**PLANNING APPEALS BY
RESIDE DEVELOPMENTS LTD AND ATHERFOLD INVESTMENTS LTD**

Land to the south of Funtley Road, Fareham

APPEAL REFS:
APP/A1720/W/21/3283643, 3284532
LPA REFS: P/20/1168/OA & P/20/1166/CU

PROOF OF EVIDENCE ON DESIGN MATTERS

APPENDIX B: SUBMITTED PARAMETERS PLAN

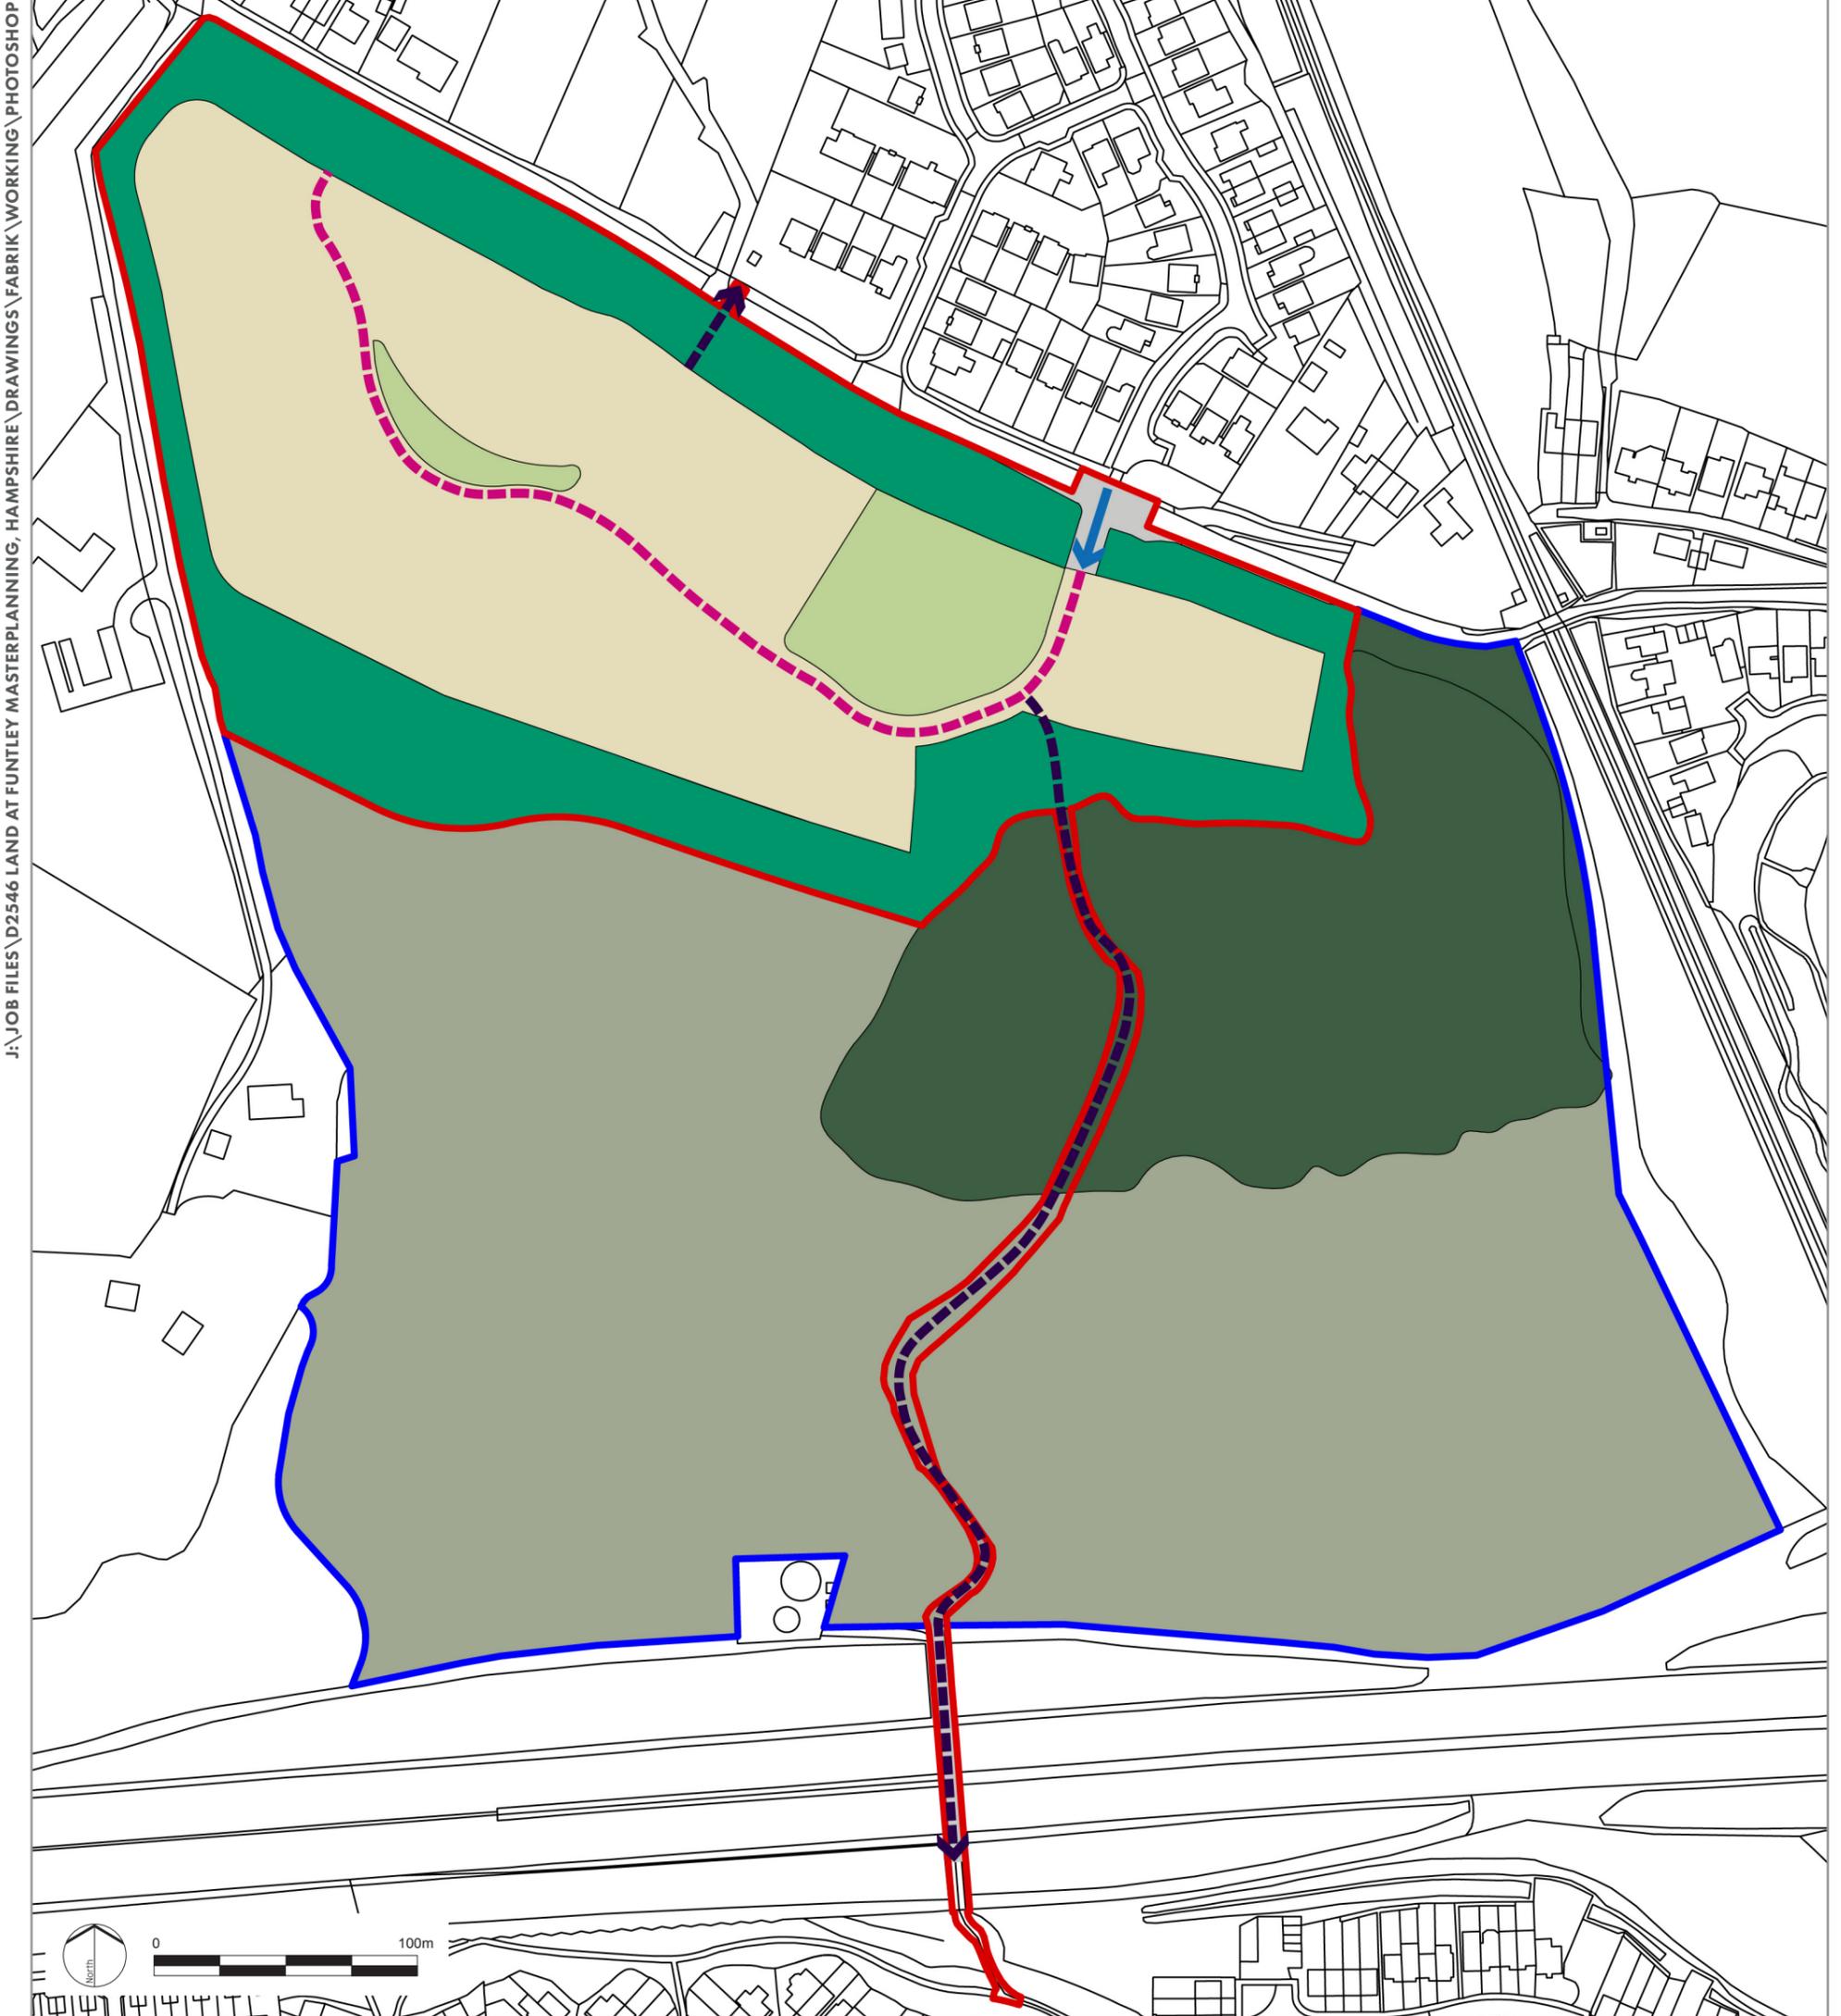
Council's Urban Design Officer first commented on the 55 unit scheme in April 2018 (Appendix A) and the basis of the submitted Parameters Plan (Appendix B). He raised a series of objections, based on the scale of the development but also a prime one related to the approach taken to enclose the development with landscape buffers which, in his view, failed to integrate the scheme properly with its surroundings. The proposals were subsequently amended, culminating in a revised and subsequently approved Parameters Plan (Appendix C: drawing D2546_032_REVI), which incorporated two "*indicative primary view corridors*" involving areas or strips of open space through the layout, as well as a revised routing for the permissive path. He confirmed in his following comments (Appendix D) that the plan met the principles established by the draft Local Plan framework at that time. The final revised illustrative Masterplan he refers to is appended at Appendix E (drawing D2456_008_REVG).

- The parameter plan does not show a 15m buffer adjacent to Funtley Road.
- There needs to be an agreement as to the precise boundary of the woodland/SINC as the proposed parameter plan does not align with the SINC boundary.

APPENDIX C: APPROVED PARAMETERS PLAN FOR 55 UNIT SCHEME

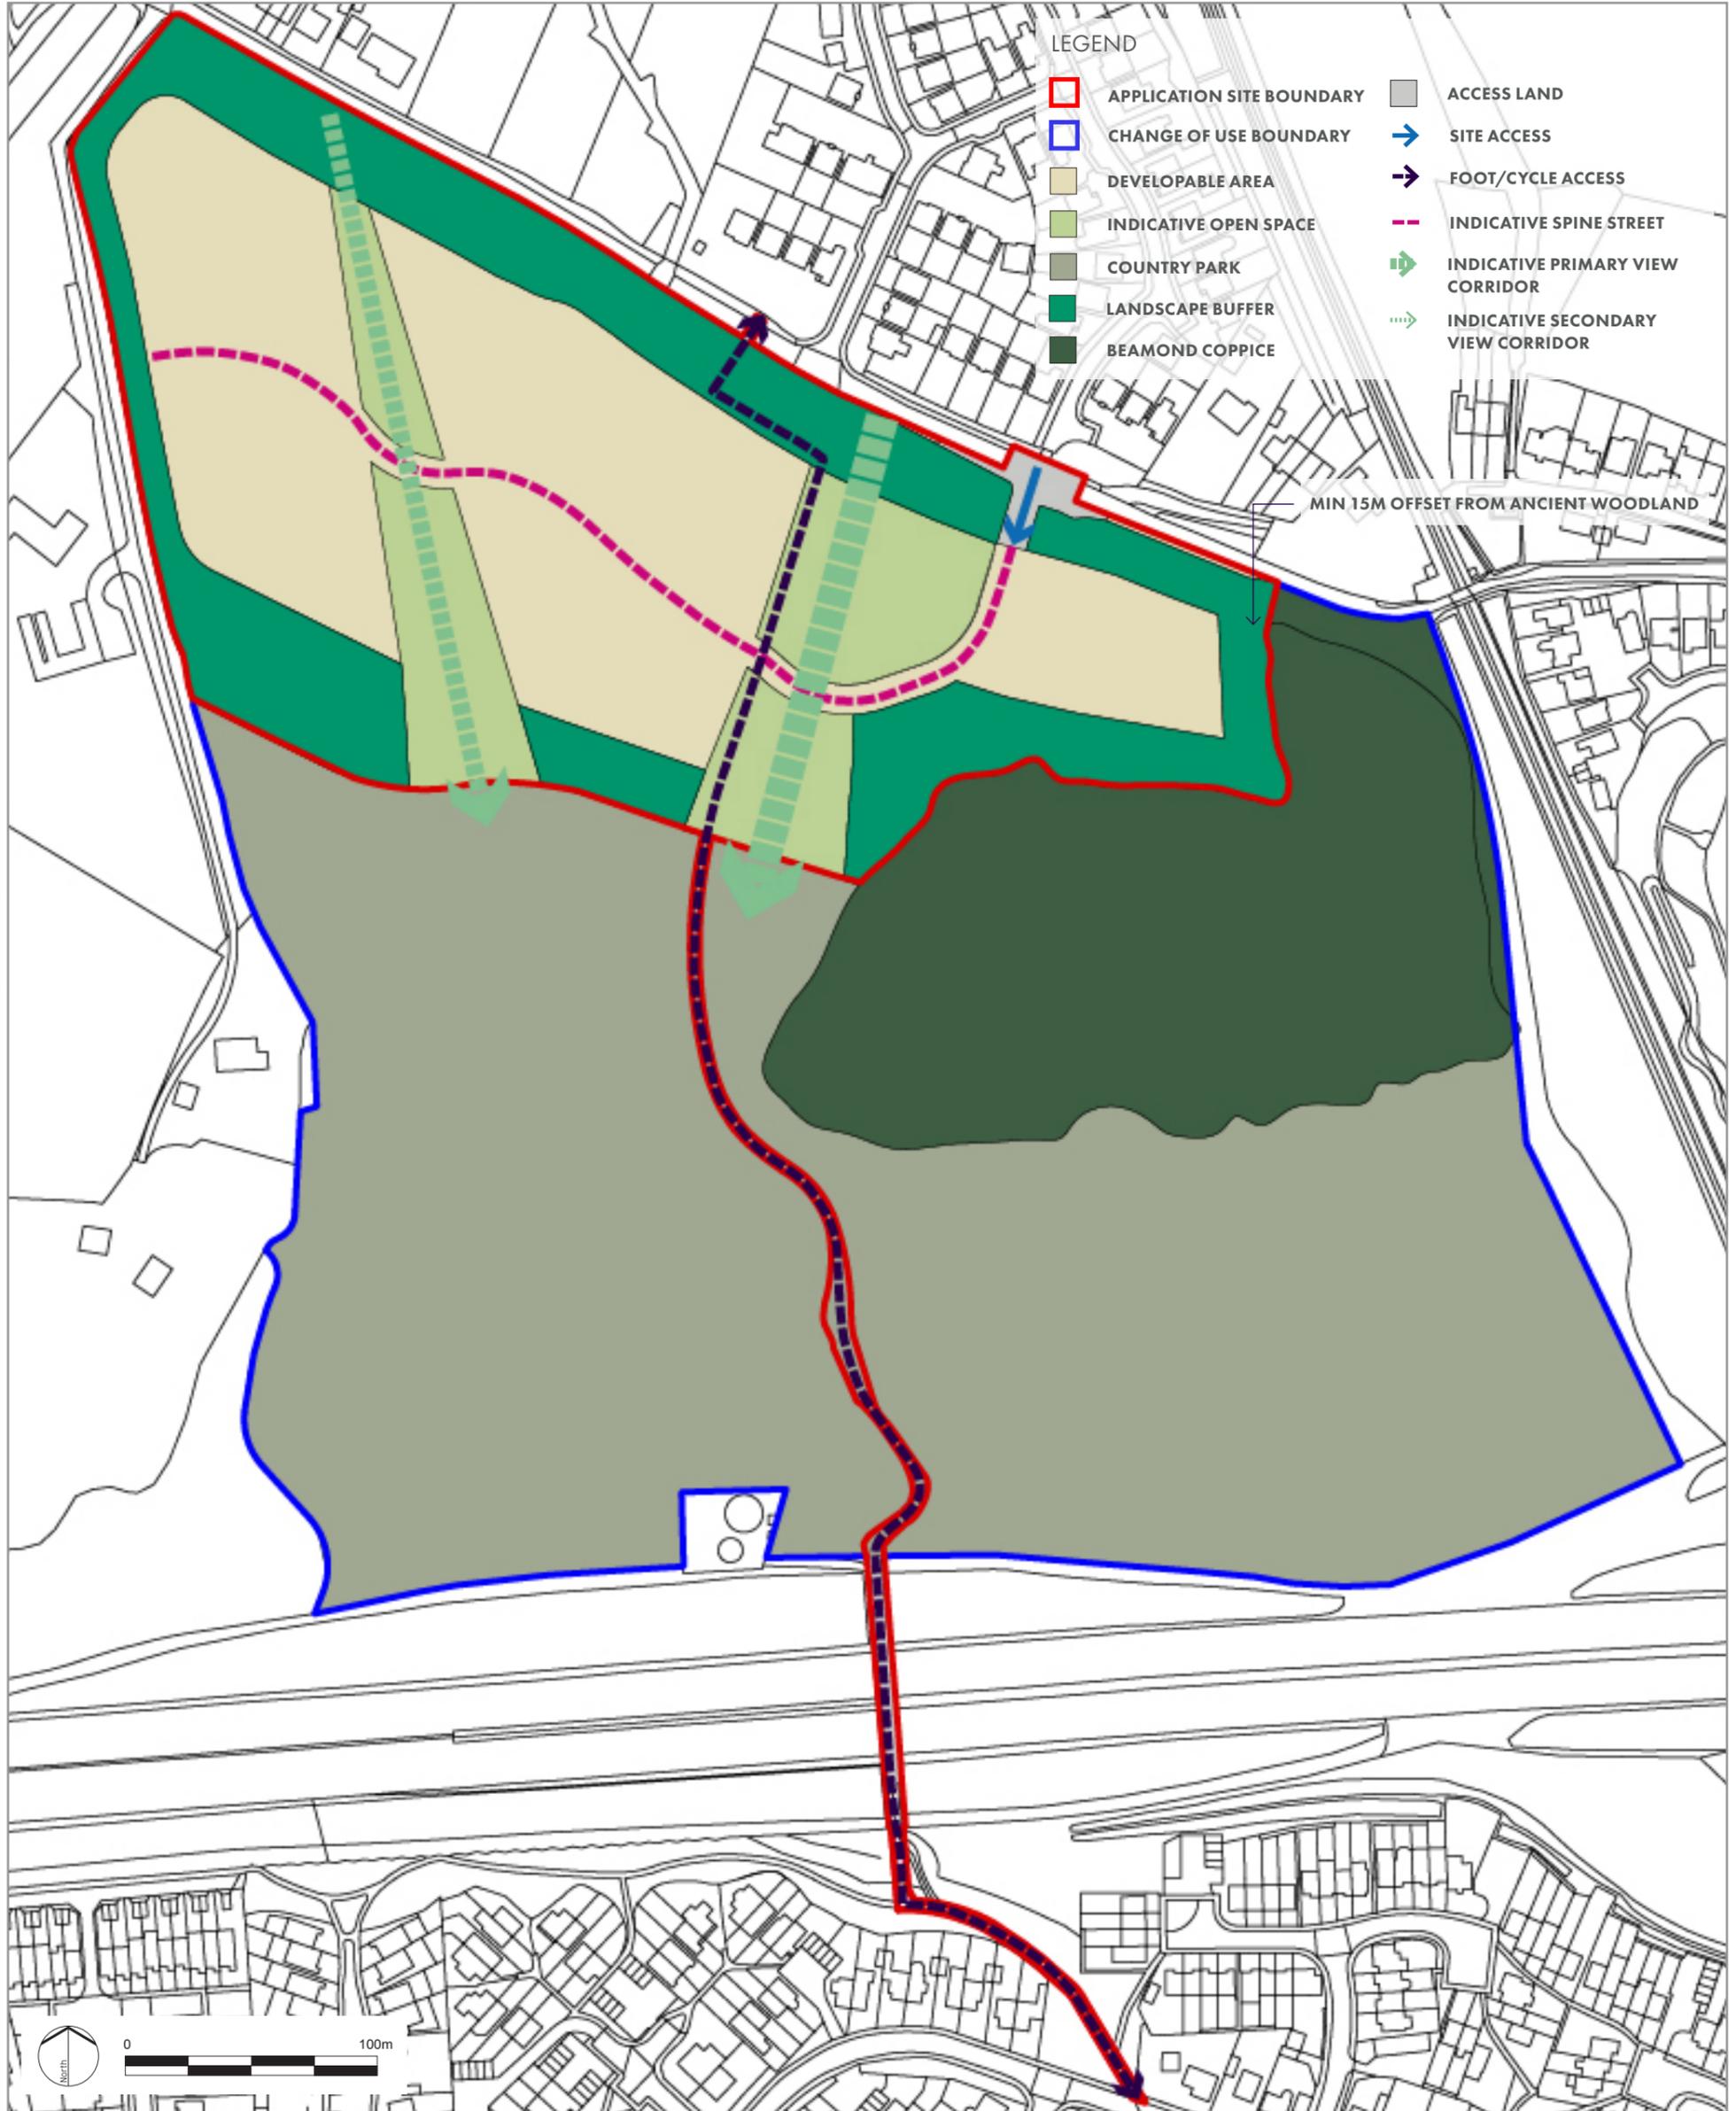
Further to our discussions, I can confirm that the revised parameter plan (and illustrative masterplan) is suitably aligned with the principles established by the Draft Plan Framework.

I have shown a snapshot below of the parameter plan identifying the net developable areas (blue boundaries) which excludes strategic open space and the principal road access. This shows a total area of some 2.48 ha, which for 55 dwellings would be approximately 22 dph. this is slightly above the Draft Framework plan that suggested approximately 20dph. However 22dph should still be low enough to ensure robust planting within development plots and public space to help create a more landscape dominant development, much more so than standard 30-35dph as exists on the north side and elsewhere.
